Packet Guide

**BAR MINUTES
CITY OF CHARLOTTESVILLE
BOARD OF ARCHITECTURAL REVIEW
Regular Meeting
June 16, 2020 – 5:30 p.m.
Zoom Webinar**

SCALE	PROJECT	SHEET NO.
0 20' 40'	0020-104-101	12(5)

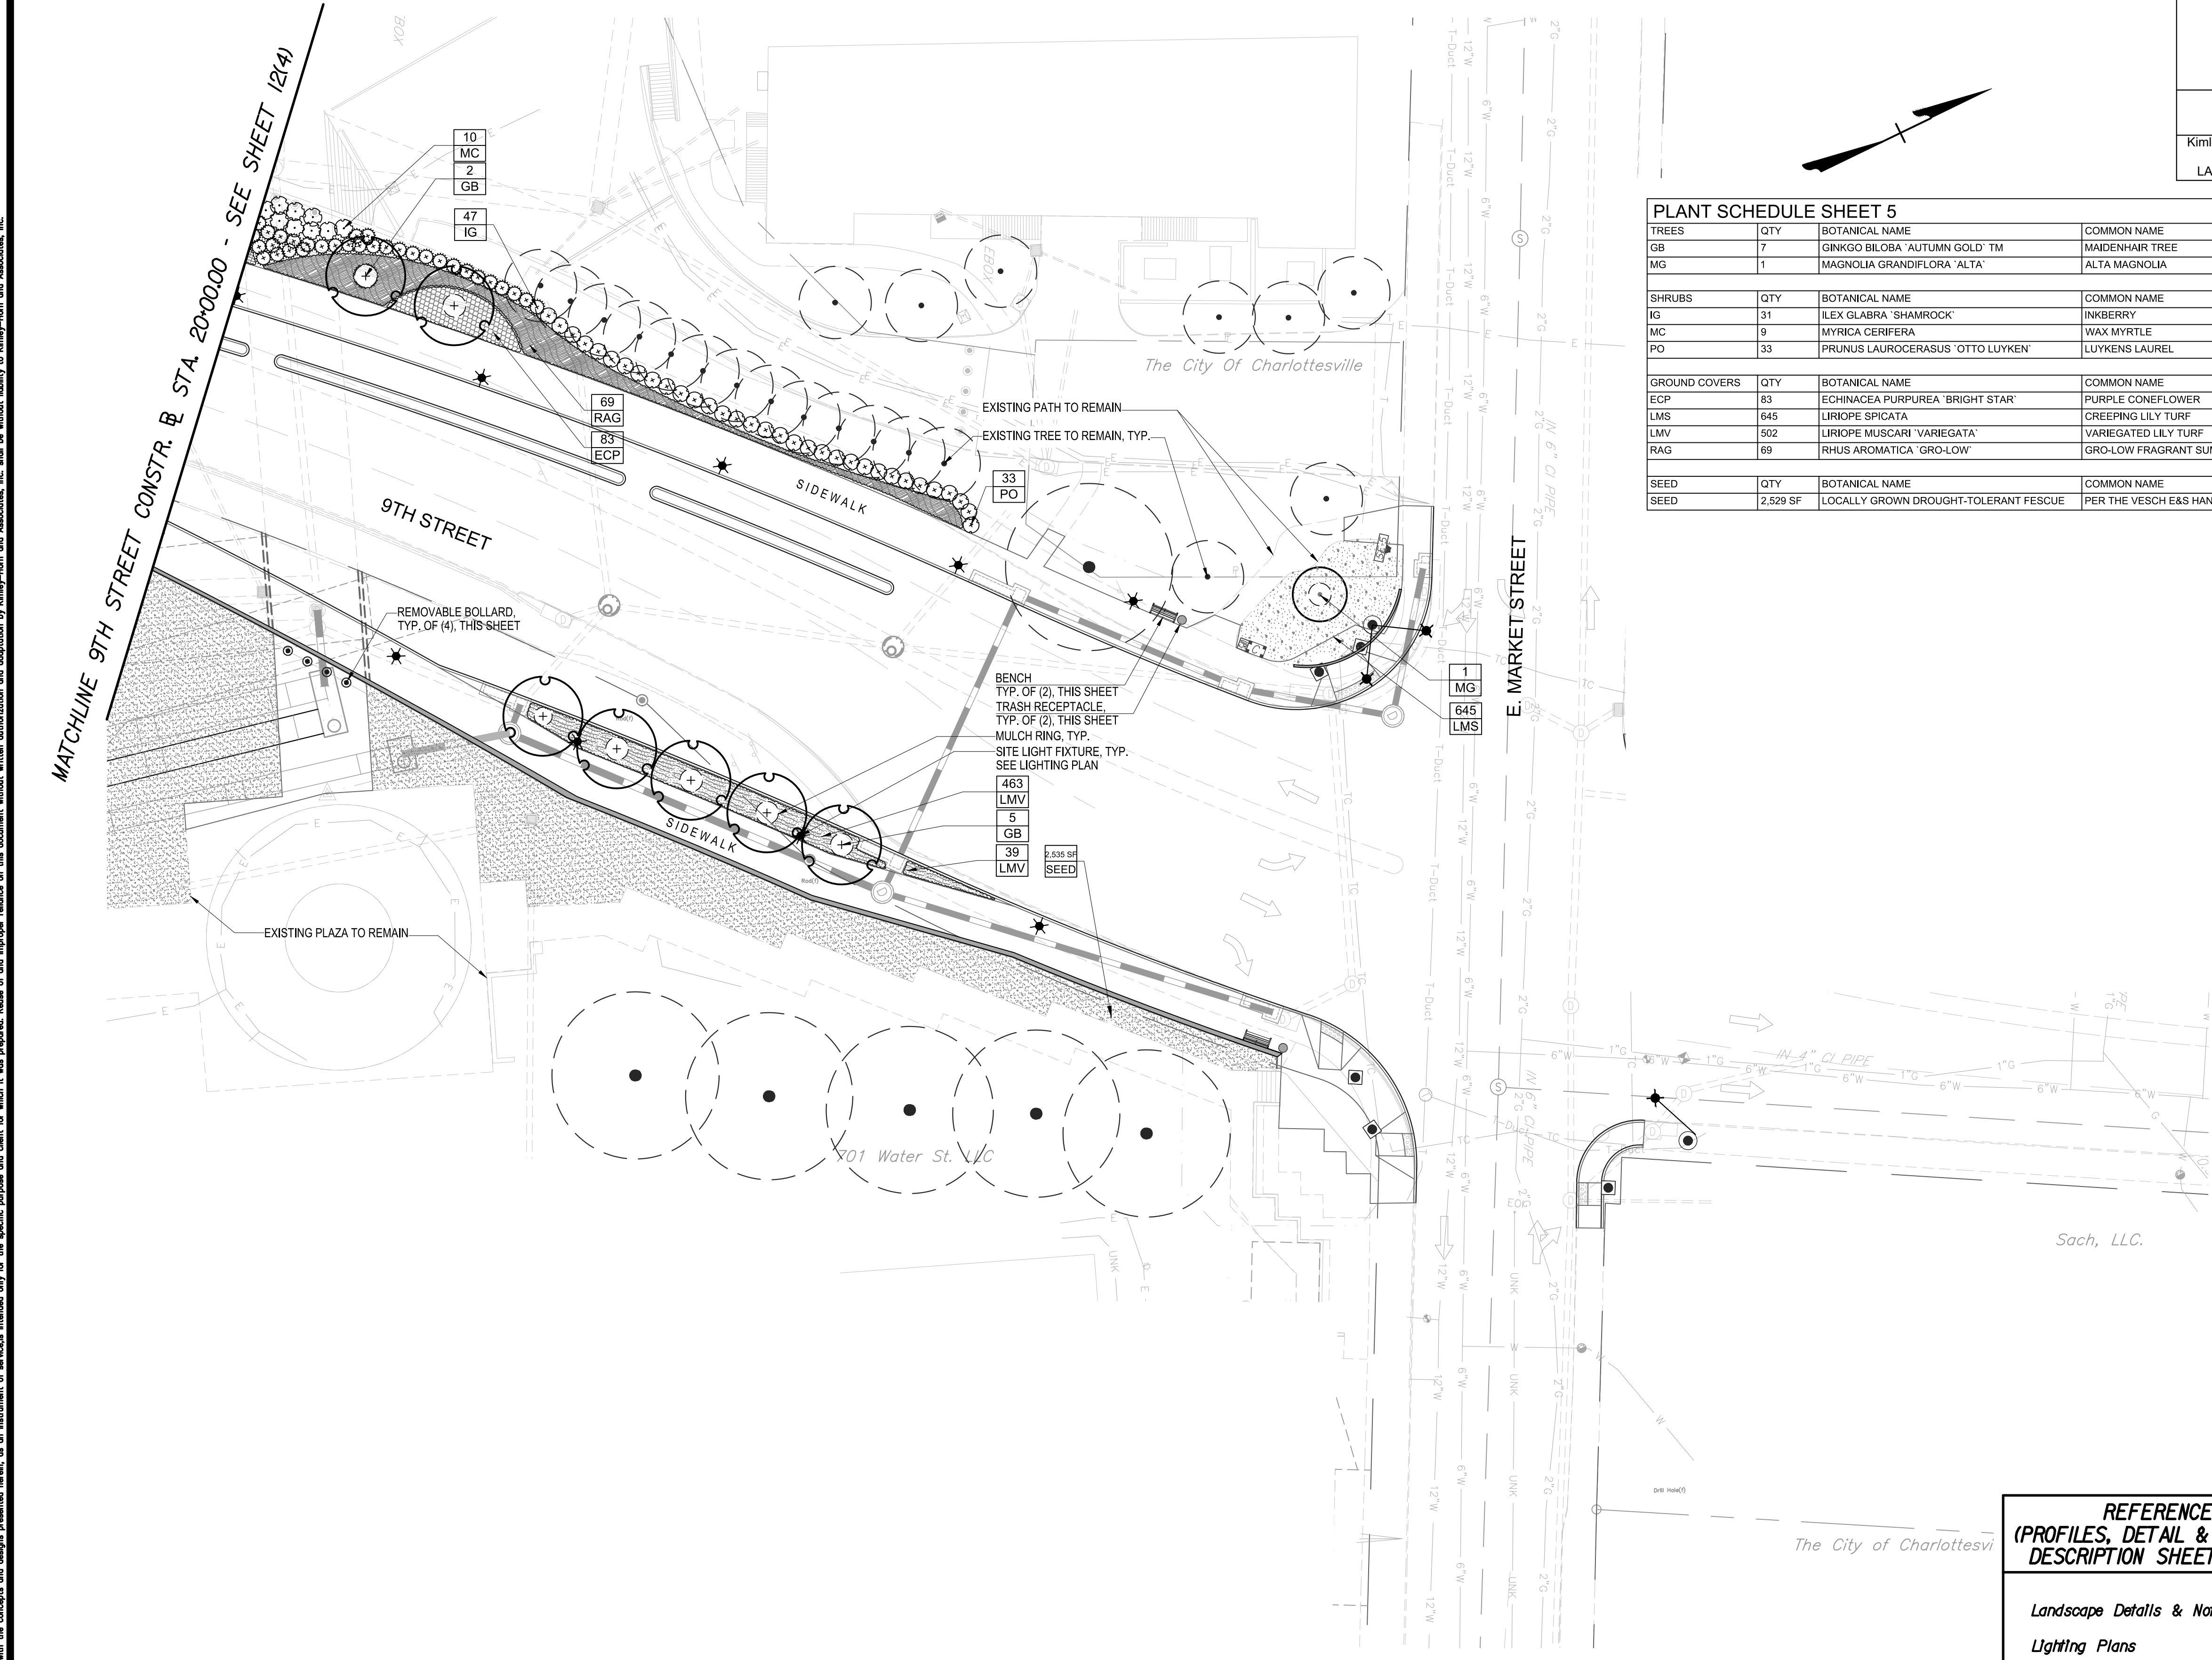
The Tree Commission reviewed the landscaping plans one additional time and requested as many large, shade trees as possible – particularly along South Street. The project team was able to add a few additional shade trees by adjusting the location and size of some trees which also required the adjustment (reduction) of shrubs and groundcover proposed. The species of landscaping proposed within the project remains the same as previously reviewed plans. Landscaping plans can be found on sheets 12(3) to 12(5).
